CLOUDED AREA IS UNDER HOLD.
BHEL to Incorporate following Comments

TATA CONSULTING ENGINEERS LIMITED
VENDOR DRAWING REVIEW STATUS

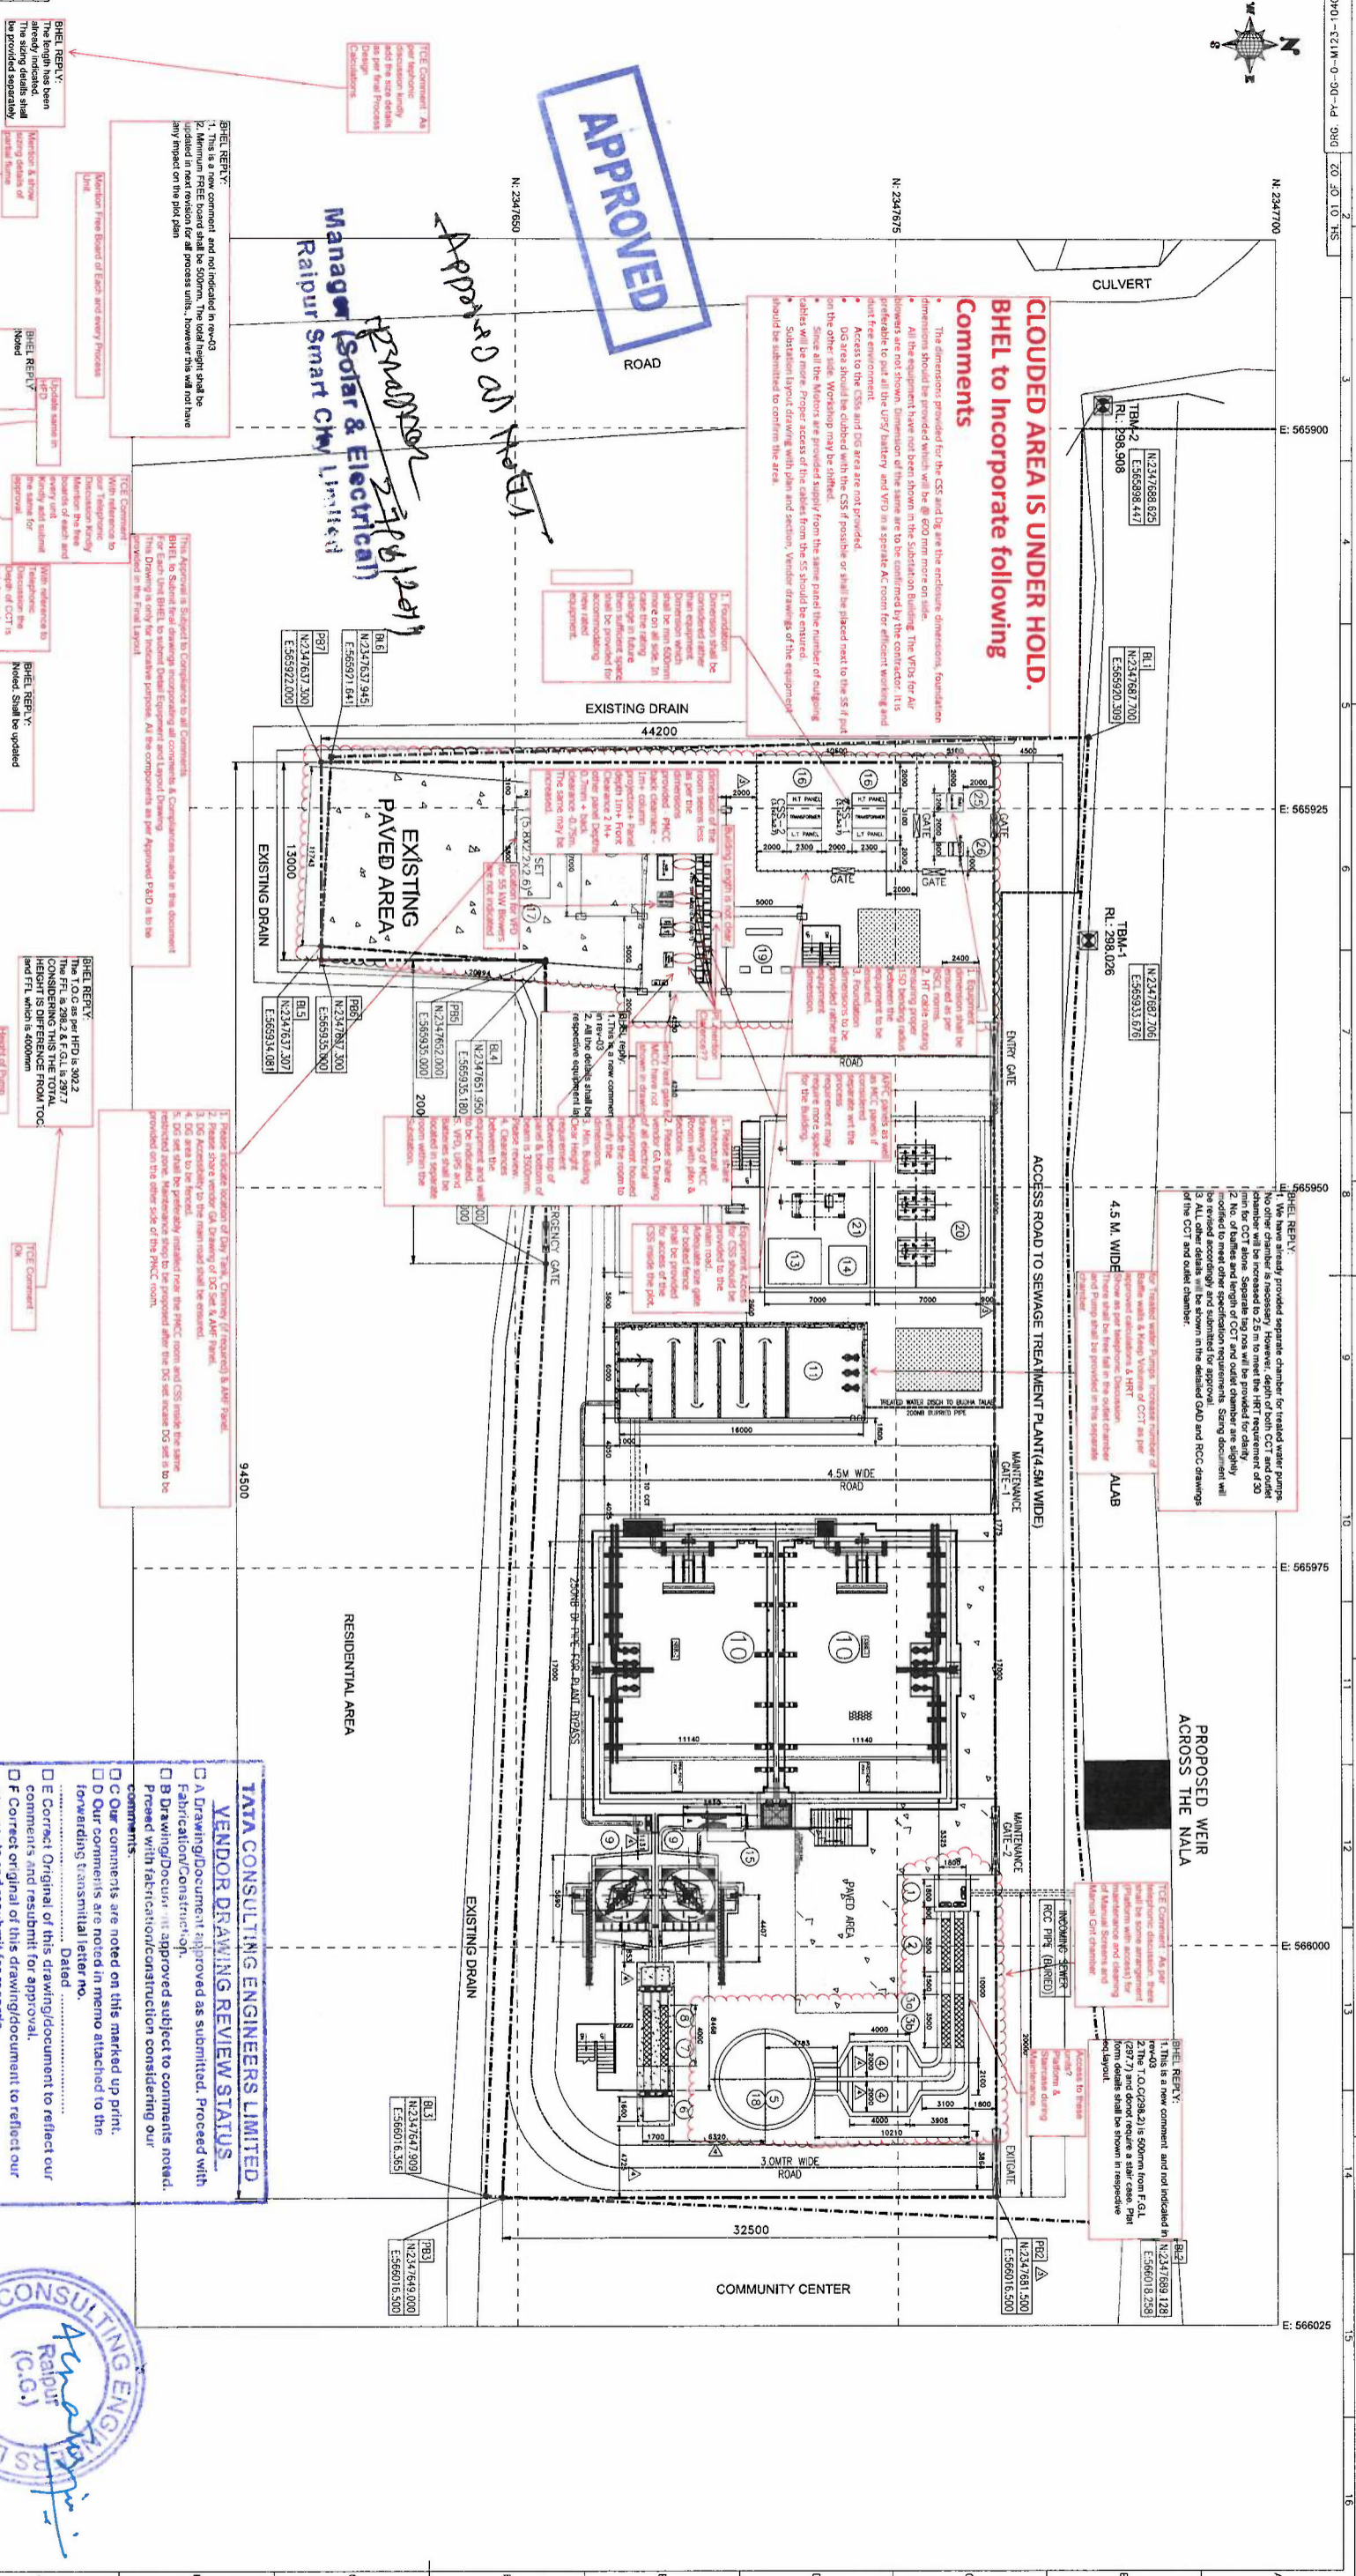
- The dimensions provided for the CS and DG are the enclosure dimensions, foundation dimensions should be provided which will be @ 600 mm more on side.
- All the equipment have not been shown in the Substation Building. The VFDs for Air blowers are not shown. Dimension of the same are to be confirmed by the contractor. It is preferable to put all the VFDs and VFD in a separate AC room for efficient working and safety.
- Access to the CS and DG area are not provided.
- DG area should be clothed with the CS if possible or shall be placed next to the SF 6 gas on the other side. Workshop may be omitted.
- Since all the Motors are provided supply from the same panel the number of outgoing cables will be more. Proper access of the cables from the CS should be ensured.
- Substation layout drawing with plan and section, Vendor drawings of the equipment should be submitted to confirm the area.

BHEL REPLY: comment and not included in report
 1. Minimum Free Board shall be 500mm. The total height shall be included in next revision for all process units, however this will not have any impact on the plot data
